APPLICATION FOR PERMIT TO DRILL

2. NAME OF OPERATOR: J. M. HUBER CORPORATION		7. UNIT or CA AGREEMENT NAME: N/A
3. ADDRESS OF OPERATOR: 1050 17th ST. #700 CITY DENVER STATE CO ZIP 80265		8. WELL NAME and NUMBER: HUBER-STATE 3-16

ON-SITE PREDRILL EVALUATION
Division of Oil, Gas and Mining

APPLICATION FOR PERMIT TO DRILL STATEMENT OF BASIS

Casing Schematic

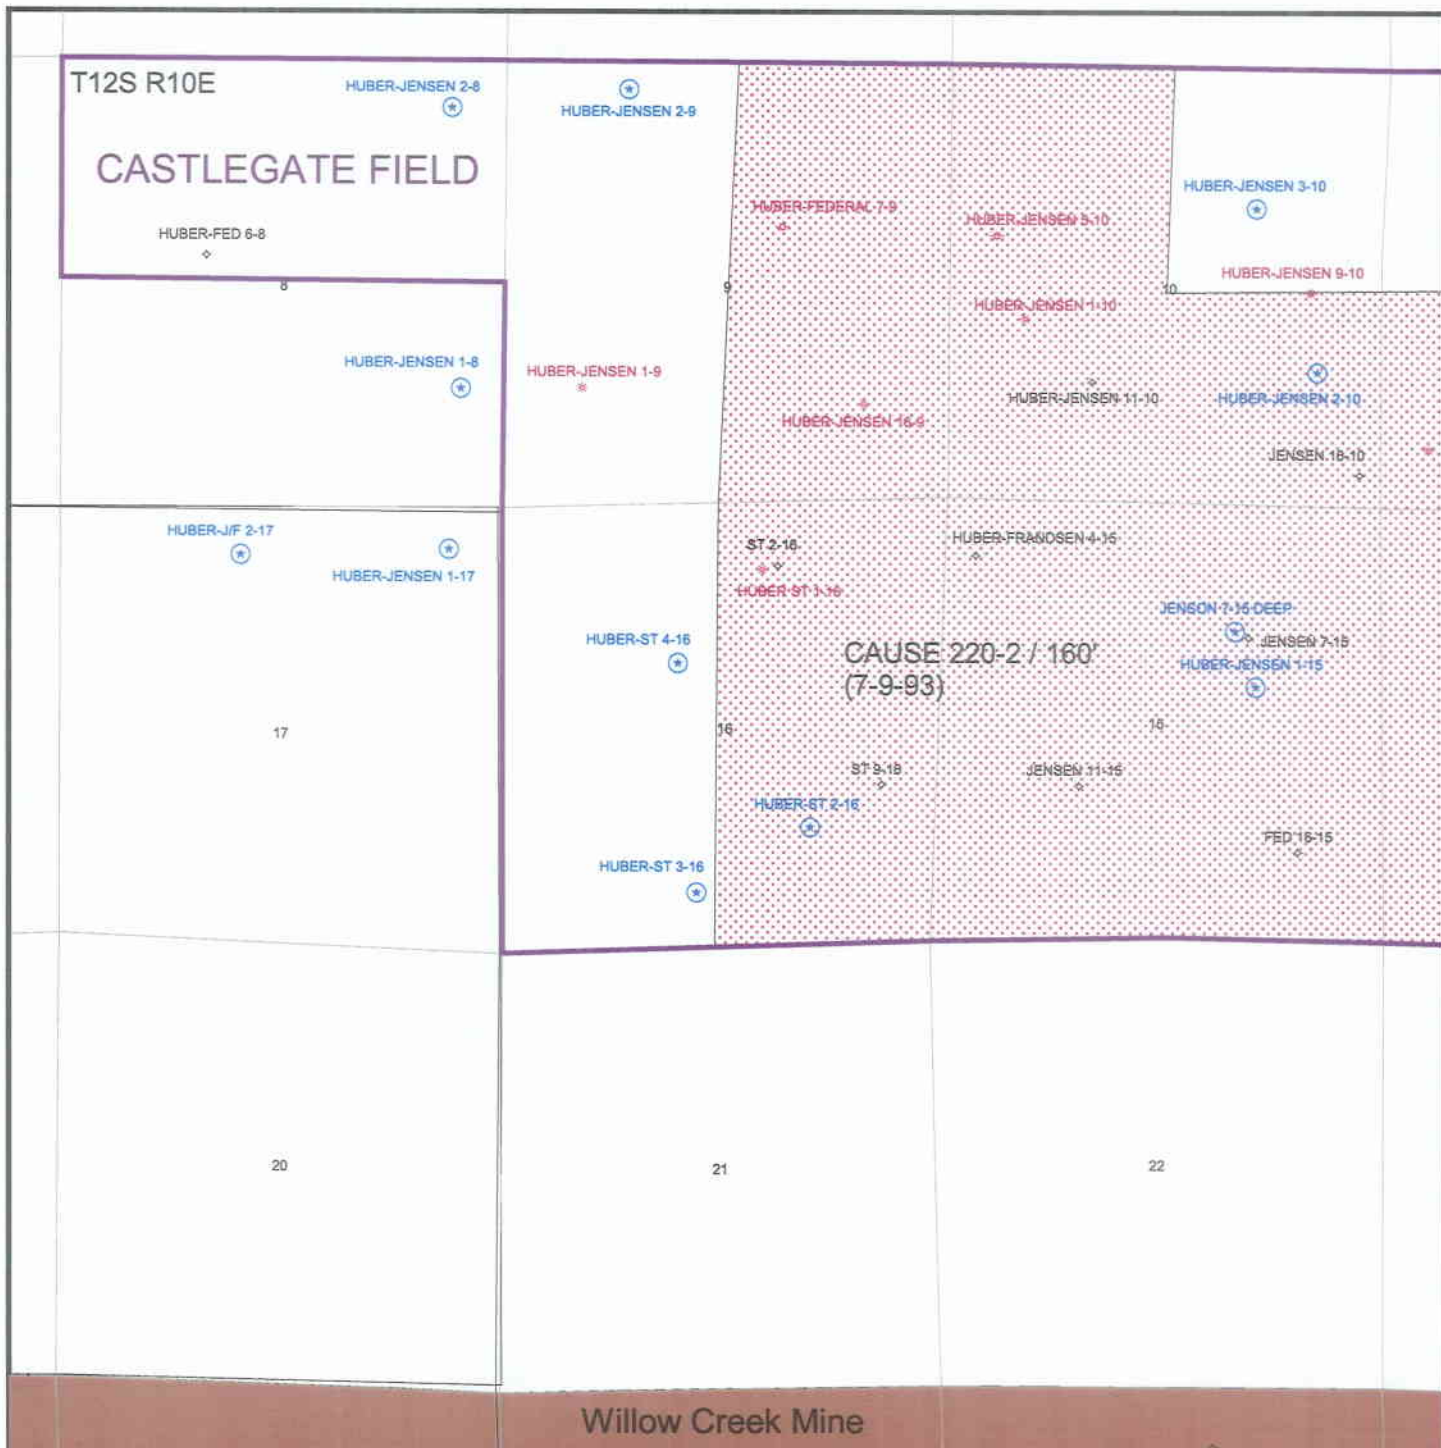
Fracture
150'
Nurtal Horn
PM
8-5/8"
MW 8.7
Frac 19.3

BHP
 $(0.052)(9.1)(5500) = 2603 \text{ psi}$
 Anticipated = 2200 psi

Gss
 $(0.12)(5500) = 660 \text{ psi}$
 MASP = 1943 psi
 Ant. MASP = 1540 psi

2m BOP proposed
 Adequate
 DRD 9/5/01
